[Docket No. 2001-SW-53-AD]

#### Airworthiness Directives; Bell Helicopter Textron, A Division of Textron Canada Model 407 Helicopters

**ACTION:** Supplemental notice of proposed rulemaking; reopening of comment period.

Figure 1. Preflight Check of the tailboom

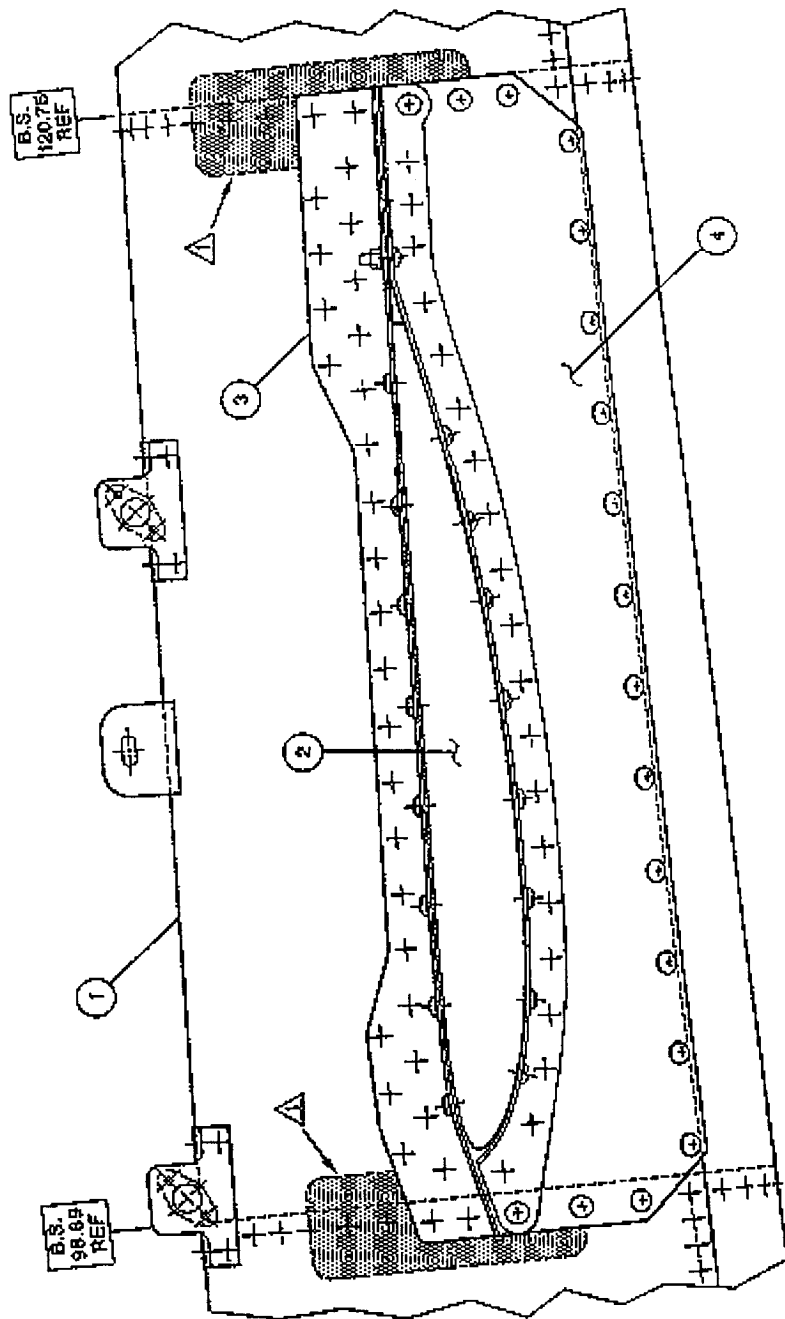
| Applicable tailboom   | Compliance time                     | Actions  | In accordance with   |
|---|-------------------------------------|--|----------------------|
| (a) Tailboom, P/N 407-030-801-101 and -105, that have not been modified in accordance with Bell ASB 407-01-048, Revision B, dated April 25, 2002. | Before the first flight of each day | Visually check the tailboom for cracks. An owner/operator (pilot) holding at least a private pilot certificate may perform the visual check required by this paragraph, but must enter compliance with this paragraph into the helicopter records in accordance with 14 CFR 43.11 and 91.417(a)(2)(v). | Figure 1 of this AD. |

- Δ Examine these areas for cracks on left side of tailboom only.
- 2. Horizontal stabilizer not shown for clarity.
